## CCNPP3COLA PEmails

To: James Steckel, NRC  
From: June Sevilla  
Subject: Request NRC action on Plausible Earthquake Fault at Calvert Cliffs - scientific information for CC3 FSAR consideration, Docket No. 52-016  
SRP Section: 02.05.04 - Stability of Subsurface Materials and Foundations  
Application Section: 2.5.4

Request for Additional Information No. 218 (eRAI 4332) DRAFT

Docket No. 52-016  
SRP Section: 02.05.04 - Stability of Subsurface Materials and Foundations  
Application Section: 2.5.4

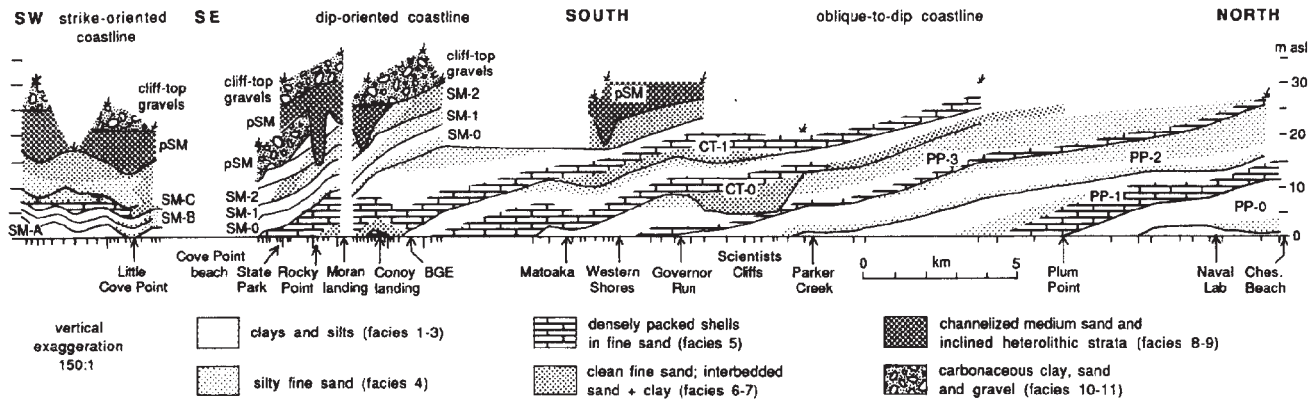
The entire succession, including cliff-top gravels of probable Pleistocene age, appears to be offset a few meters along a down-to-north fault at Moran landing (valley with unnamed stream 2 km south of BGE plant). Some fault-offset or related folding might also exist in the Cove Point beach area, inasmuch as St. Marys strata cannot be readily correlated across this gap in exposure (see later discussion).

Vogt has raised concerns regarding the possible existence of a geological fault line located in the vicinity of the CCNPP. An indication of the fault along the cliffs south of the power plant is apparently suggested in a scientific paper by the paleontologist Susan Kidwell of the University of Chicago published in 1997. It would be extremely difficult for anyone other than a professional in her field to ascertain that she might be discussing a geological fault exposed in the cliffs. Dr Kidwell calls our attention to an area of the cliffs where offsets in the stratigraphic sequence of beds are indicated. While she does not specifically state it, such offsets commonly indicate breaks in sedimentary beds, possibly due to faults or perhaps significant folds in the original orientation of the beds. Vogt has helped to define this work by noting that the exposure is approximately 1 ¼ miles south of the power plant at a site called Moran's Landing. I am not familiar with this site, but it appears to be located near the mouth of a stream called Thomas Branch in the Calvert Cliffs State Park. It will help you to visualize the probable fault location by using Google Earth and focusing on the state park. Click on some of the blue squares along the parks shoreline until you find one labeled Thomas Branch. At this point you will see two streams that intersect near the beach. One has a NE/SW trend while the other trends NW/SE. If you back out enough to change the scale of the photo image to see St. Leonard Creek to the west, you will also see a cove at Vera's marina at White Sands. It has the same NW/SE trend and apparently connects with the ravine with the same trend at Thomas Branch. Such erosion patterns often reflect underlying zones of weakness in the underlying sediments. In some cases this erosion occurs along fault planes (these are really common in California, for example). In other cases it might occur in anomalies in the underlying sediments. A good example would be erosion of a buried stream channel. Linear erosion patterns are more suggestive of underlying fractures.

RE JSR paper: In addition to the cross-section, which speaks for itself, there's a section on p.324 labeled "Modification of original dip" that will be of interest. The section on the SM-O disconformity will also be of interest, including the subsection "alternative stratigraphic interpretations" and "biostratigraphic corroboration". These spell out the reasoning as well as highlight the data supporting the SM-0 surface as the key discontinuity in this part of the record.

**RECOMMENDATION:** Given the possibility, or even probability, that a significant neotectonic structure, “Moran’s Landing Fault?”—a post-Miocene and potentially active earthquake-generating fault that offsets the strata exposed in the Calvert Cliffs such that the land on the south side has moved up relative to the north side—passes within 1 ¼ mile or less of the Calvert Cliffs Nuclear Power Plant, and that past CCNPP risk assessments—including the 2009 preliminary PSC report-- have failed to take this potentially seismically active (with high-frequency accelerations due to fault proximity) structure into account, this appeal recommends the following:
